CITY OF SUGAR HILL

IFB # 26-001 – ROADWAY IMPROVEMENTS ON VARIOUS CITY ROADS

ADDENDUM #1

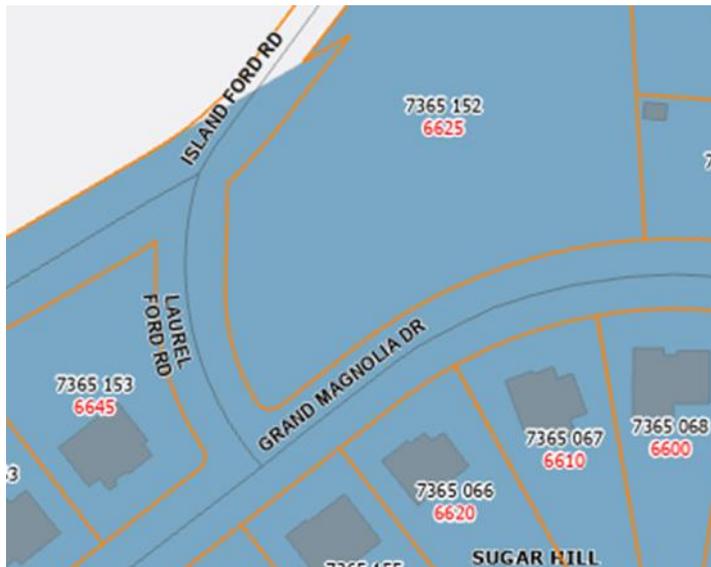
Can you provide the exact location of Laurel Ford Rd. I am unable to locate it on Google earth? **See below.**
